VILLAGE OF GERMANTOWN
N112 W17001 MEQUON ROAD, GERMANTOWN, WI 53022

MEETING:	**PLAN COMMISSION**
DATE AND TIME:	**MONDAY, February 14, 2022 6:30 p.m.**
LOCATION:	**Germantown Village Hall Board Room, N112 W17001 Mequon Road**

2020 LAND USE PLAN MAP AMENDMENT, REZONING & CERTIFIED SURVEY MAP (CSM) APPLICATIONS

2/14/22 Plan Commission Meeting

SEE SHEET 2 FOR WETLANDS

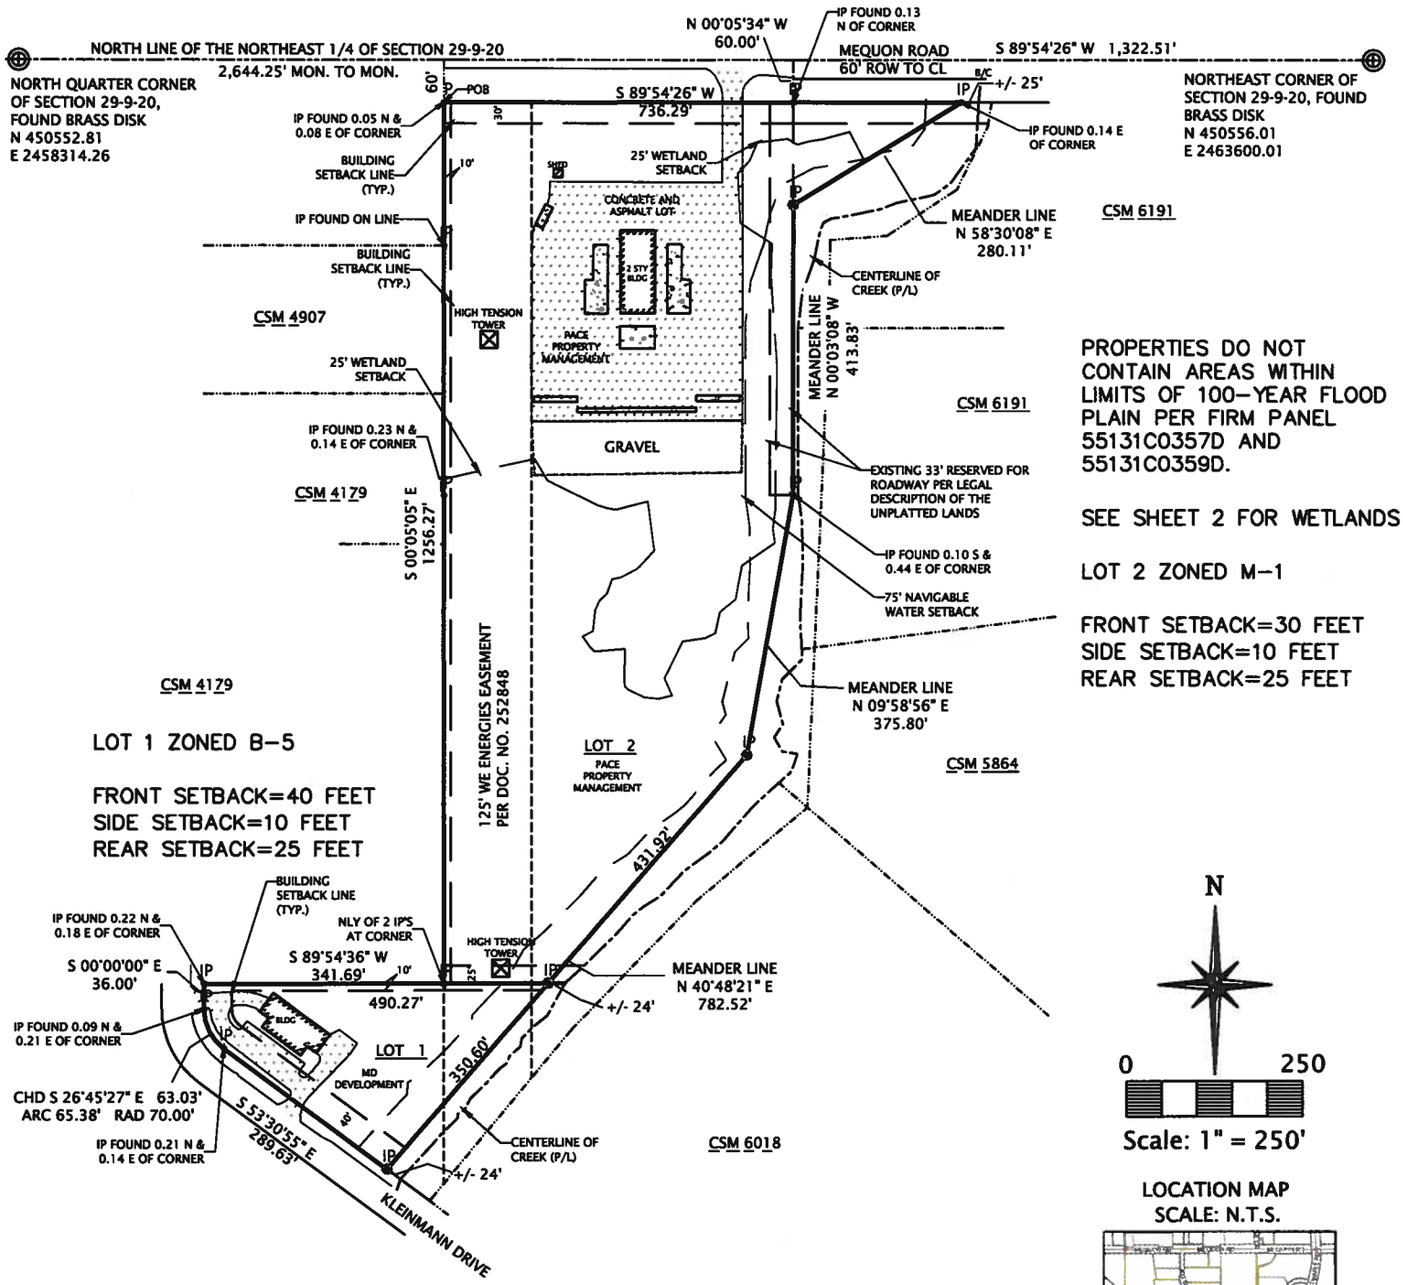
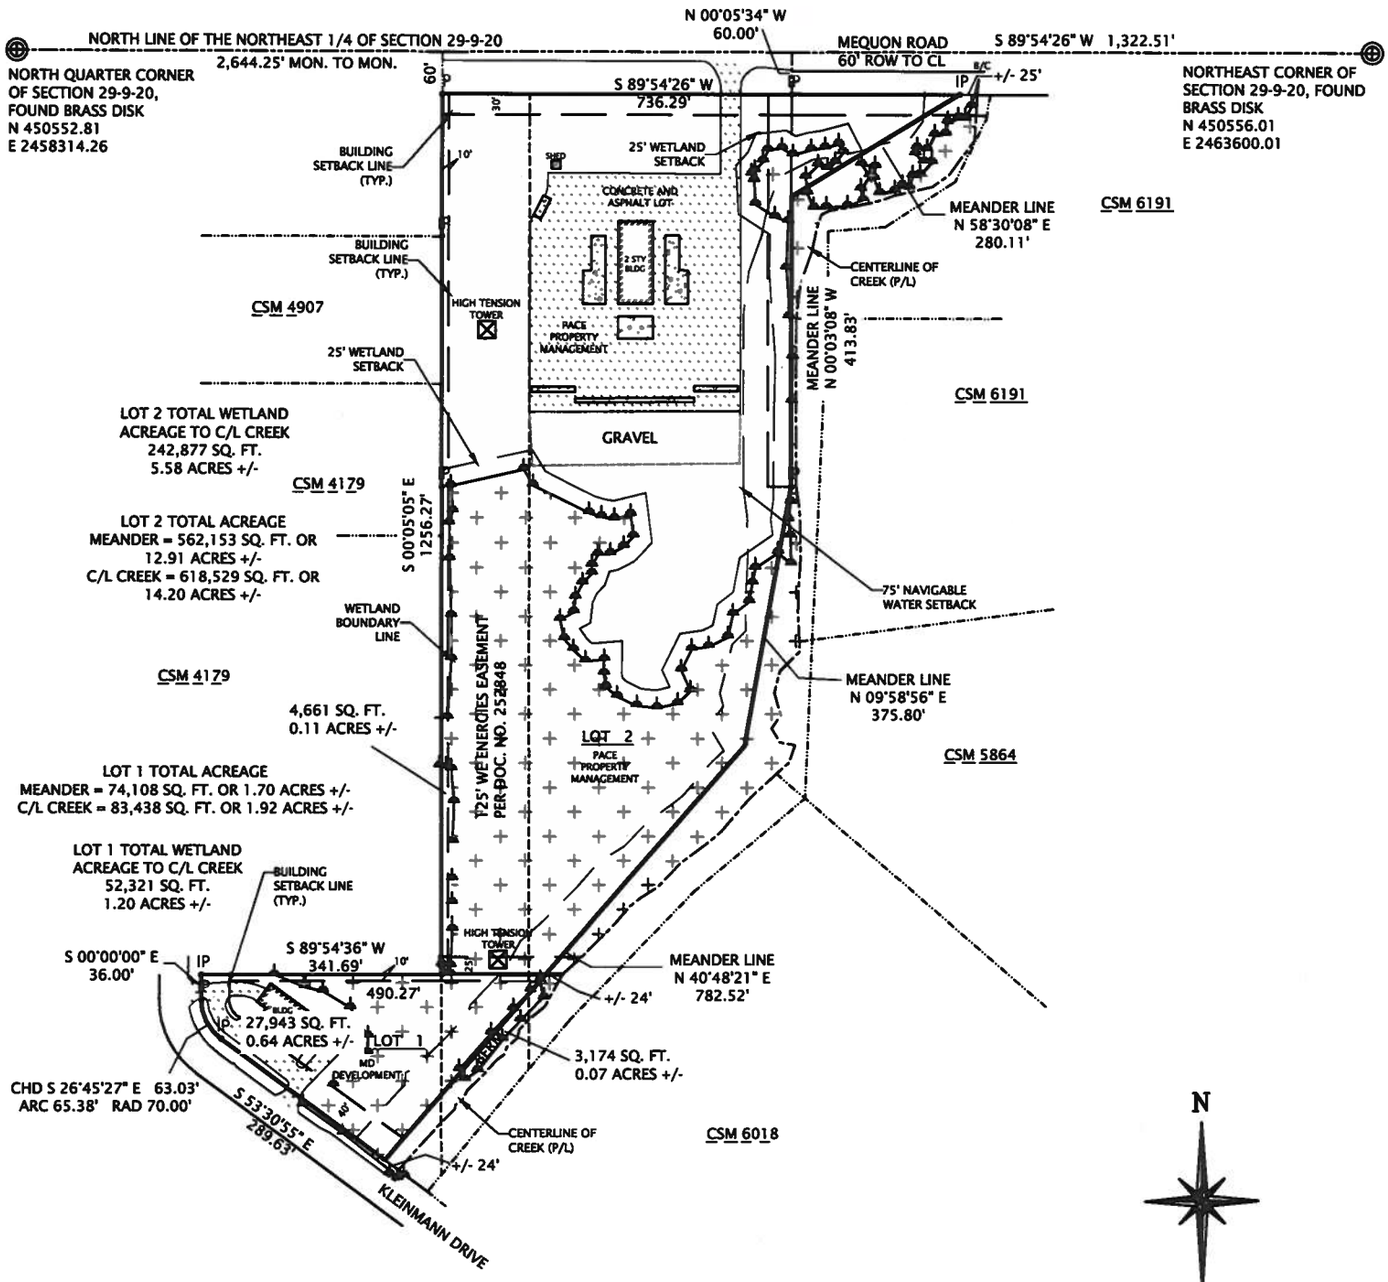
1. Building setback lines are to be mapped and dimensioned.
2. Village of Germantown requires all lands abutting a public road to be dedicated.
3. Label the NW corner of the NE ¼, describe the monument type and show the dimension along the North line of the NE ¼.
4. Is the 33' road reservation existing or proposed? If existing, identify what document created it. If proposed, label all bearings and distances.
5. Label all physical features that are shown on the map.
6. Reference bearing should be referenced to the North line of the NE ¼.
7. Label owners name address and telephone number.
8. Label PLS name, address and telephone number.
9. Label wetland boundary line on sheet 2.
10. Identify who delineated the wetlands and when.
11. Add the following note to sheet 2:

b. The building setbacks for the Moore parcel will be for the B-5: Highway Business District and for the PACE parcel the setbacks are for the M-1: Limited Industrial District; the correct building setbacks should be on the CSM either in a note or drawn within the parcels using dashed lines

c. Why is there a note indicating “33’ reserved for roadway” on page 1?
4. The “Concept Site Plan” shows a significant area as “proposed parking lot”. This area is approximately 65,000 sqft or 1.5 acres; far exceeding the .5 acre cut-off for needing to prepare an erosion control and storm water management plan (gravel is considered an impervious surface for storm water management purposes). This “proposed parking lot” area shown on the “concept” plan also indicates impact to existing wetlands. The “Proposed Grading Plan” for the PACE property a smaller area to be filled with gravel and graded. The following questions/comments pertain to this area:

Comment noted, all lands are abutting a public road. No action performed.

3. *Label the NW corner of the NE ¼, describe the monument type and show the dimension along the North line of the NE ¼.*
